Technical Service Information

CHRYSLER A904 SHUDDER

Figure 1

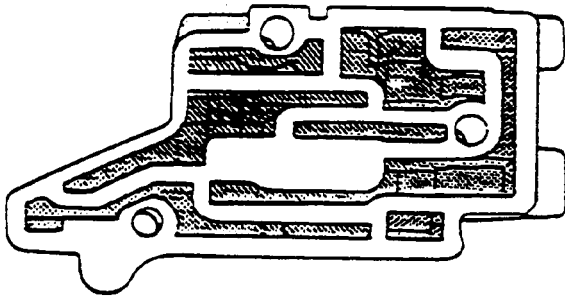
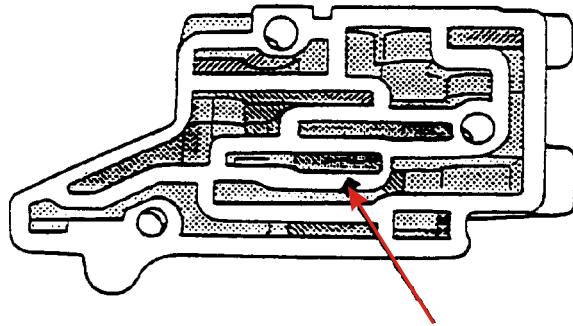
1. Remove transmission oil pan.
2. Remove valve body and inspect the lock-up valve body.
 - A. If lock-up valve body is the old style lock-up body (Figure 1), replace it with new style Lock-Up Body (Figure 2) PN 4202209 and replace the present lockup spring with a new Lock-Up Spring PN 4202672. Reuse the existing lock-up valve, fail safe valve and spring, cover, and screws.
 - B. If the lock-up valve body is the new style lock-up body (Figure 2), install only the new Lock-Up Spring PN 4202672.
3. Install the valve body and torque screws to 35 inch pounds (4 Nm).
4. Install the transmission oil pan and fill with ATF fluid.
5. Adjust shift and throttle linkage as necessary.

**VENT ADDED TO LOCK-UP BODY
NEW STYLE**
